18 August 2021
Ref: E33177Plet-ADDrev1

ADDENDUM TO PRELIMINARY AND DETAILED SITE INVESTIGATION REPORTS
PROPOSED NEW PRIMARY SCHOOL IN MULGOA RISE
1-23 FORESTWOOD DRIVE, GLENMORE PARK, NSW

JKE were provided with an Interim Advice (IA01)² prepared by Rebeka Hall of Zoic Environmental, who is an EPA-accredited site auditor. Rebeka was engaged by Richard Crookes Constructions to review the PSI/DSI in her capacity as an auditor, within an overarching scope of providing a Site Audit Statement. JKE understand that the site audit is non-statutory at this stage of the project.

Title: **GROUNDWATER CONTOUR PLAN**

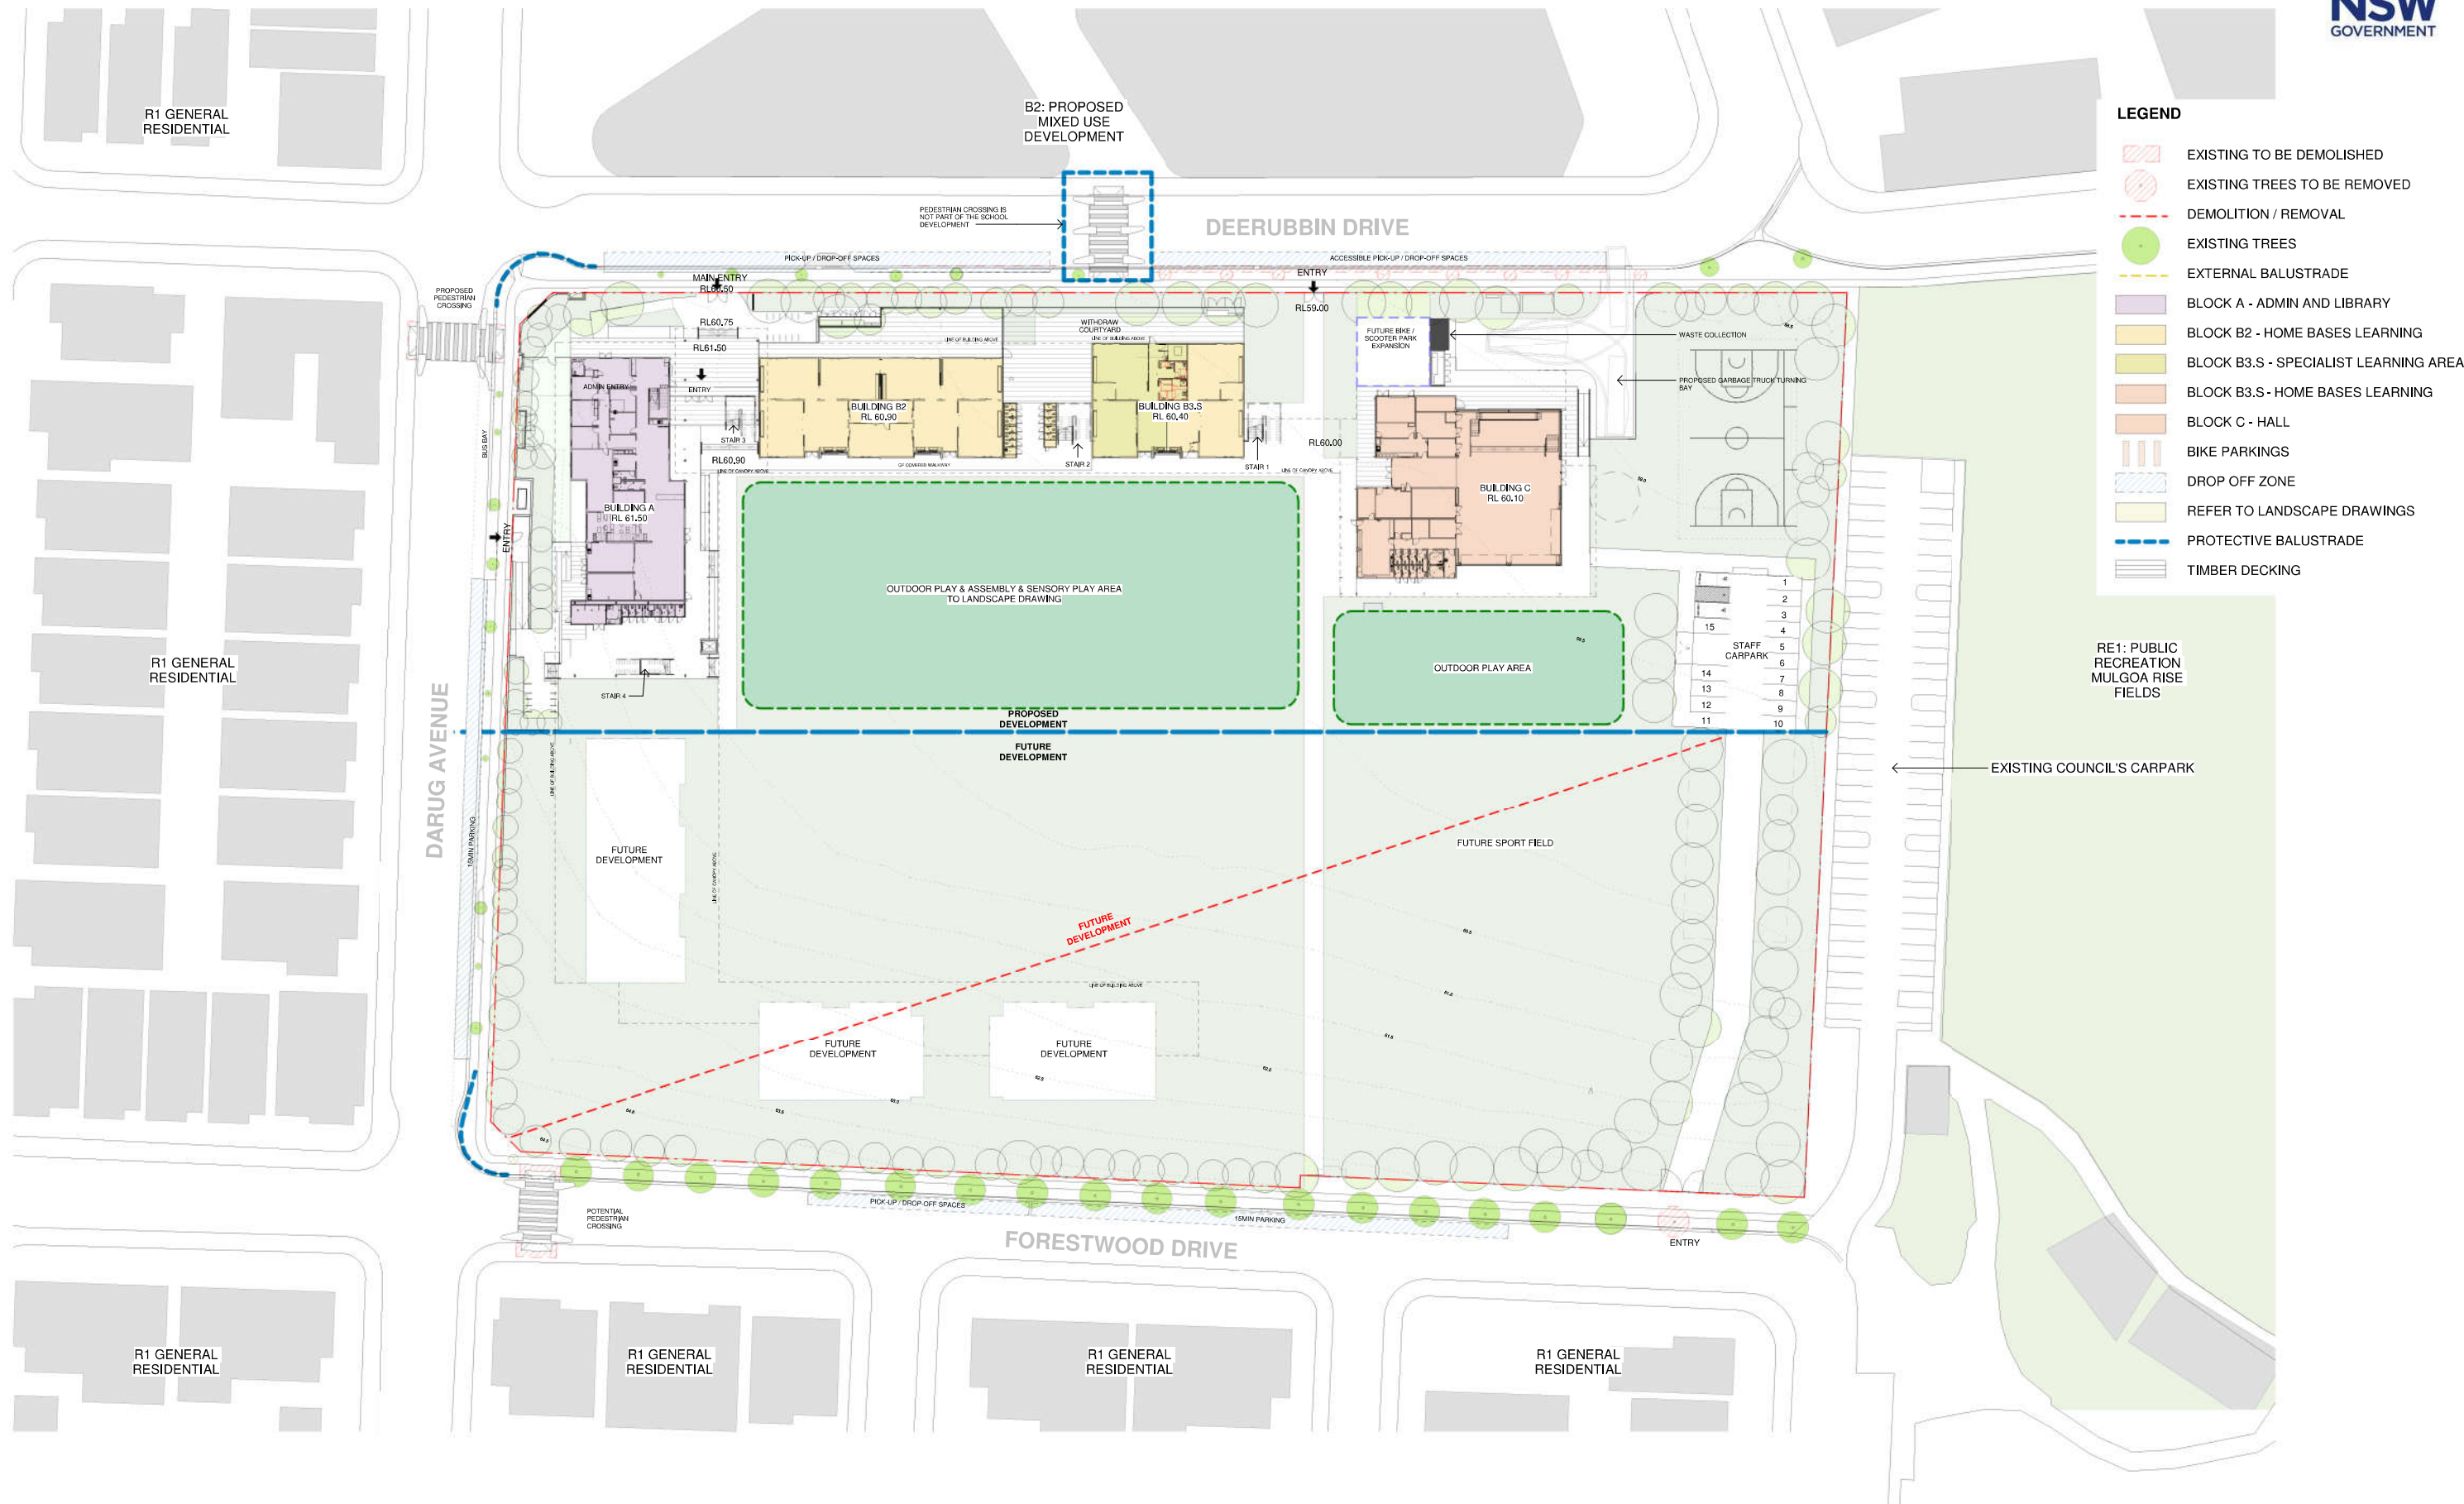
3. Monitoring wells have not been surveyed and groundwater flow direction has not been confirmed. Given the highly disturbed nature of the site groundwater flow requires confirmation, particularly considering the heavy metal exceedances noted during the groundwater sampling of MW8.

Ground surface levels at the monitoring well locations have now been interpolated based on the survey/contour information presented on Figure 2 in Appendix A. These levels were used to generate a groundwater contour plan using Surfer v8.08 (Surface Mapping Program), presented as Figure 5 in Appendix A of this addendum. The data input into the contour model was as follows:

The contour plan indicates that the groundwater flow direction is towards the north-east. This is in sympathy with the topography and generally aligned with expectations based on what was reported in the DSI.
